ADDENDUM TO VISUAL IMPACT ASSESSMENT (VIA)

CBM Caledon Project

CBM Aggregates

WSP Canada Inc.

VISUAL AESTHETICS AND CULTURAL HERITAGE

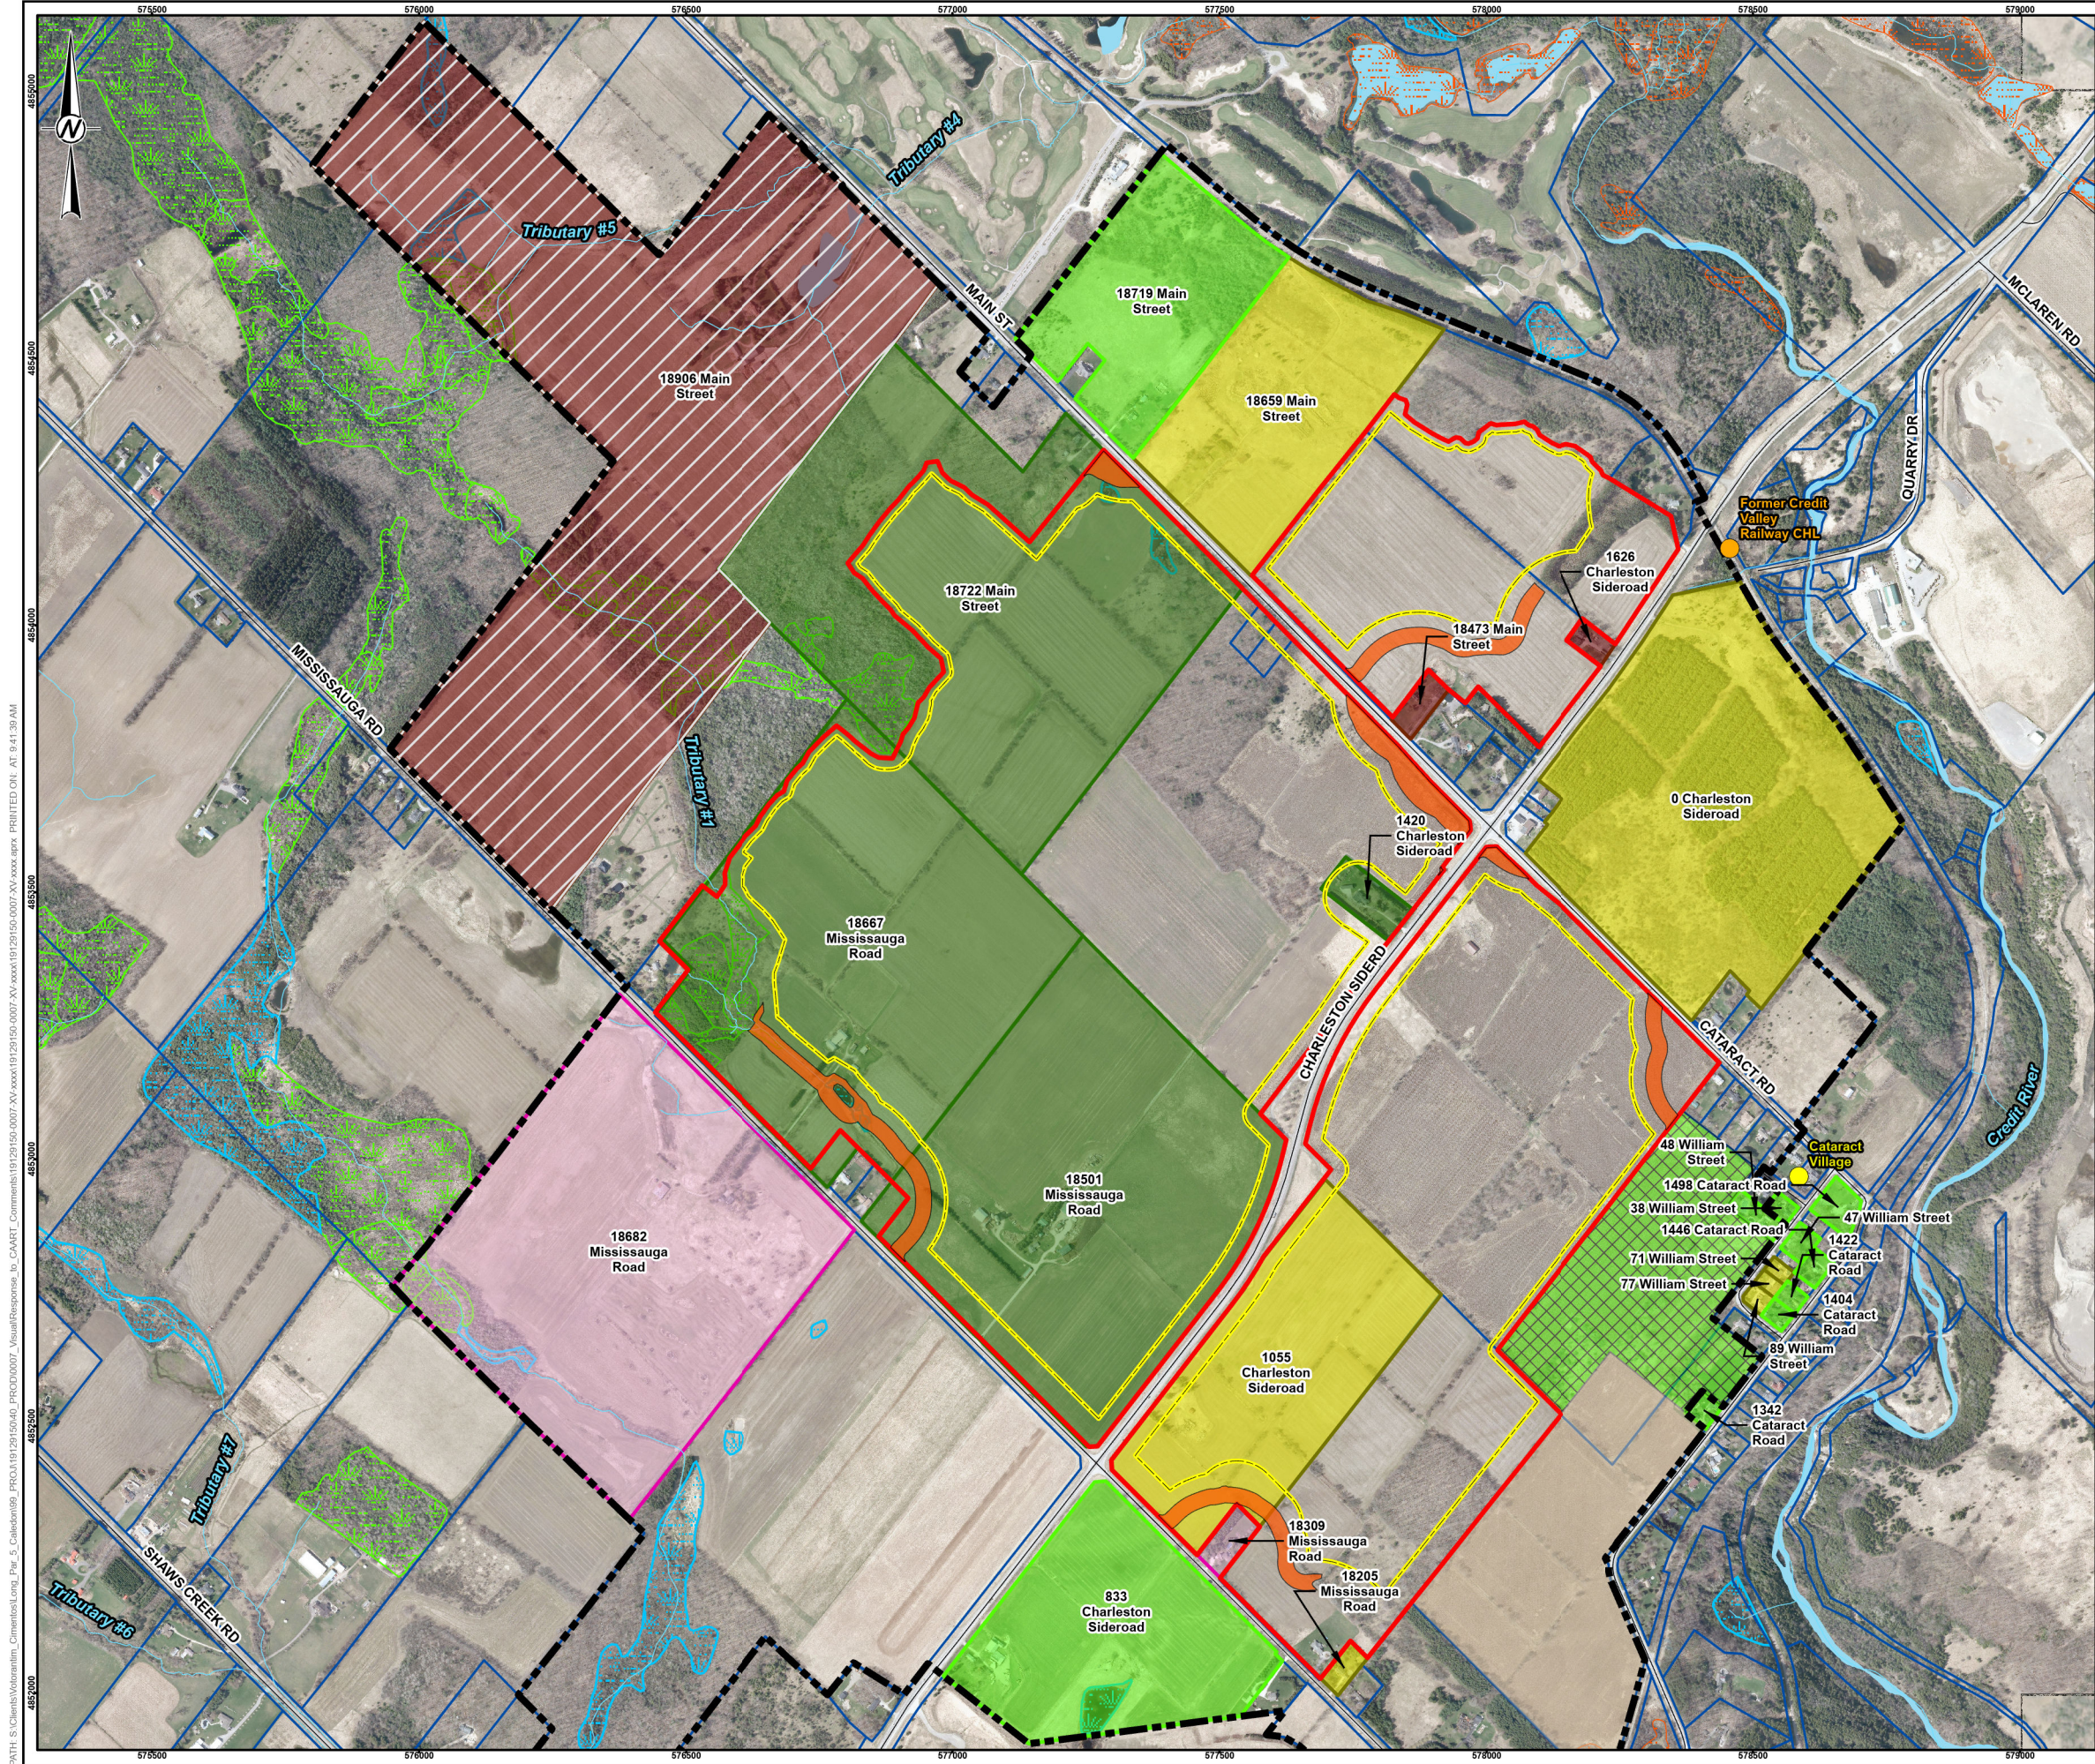
Properties listed (not designated) on the Town of Caledon Heritage Register or properties of potential built heritage resource are shown on Figure 17. The woodland planting that is being proposed between the Hamlet of Cataract and the South quarry, along with the visual planting areas, shown on Figure 17, will provide a visual screen for the majority of properties within the Hamlet of Cataract. Views of the extraction area from the properties at 18667 and 18501 Mississauga Rd. will be screened by visual planting areas, berms or vegetation that will be left in place within the Licence Boundary or Additional Lands Owned / Controlled by CBM. The existing

vegetation, residence and any other structures to remain at 1420 Charleston Sideroad will provide a visual screen of the extraction area from Charleston Sideroad.
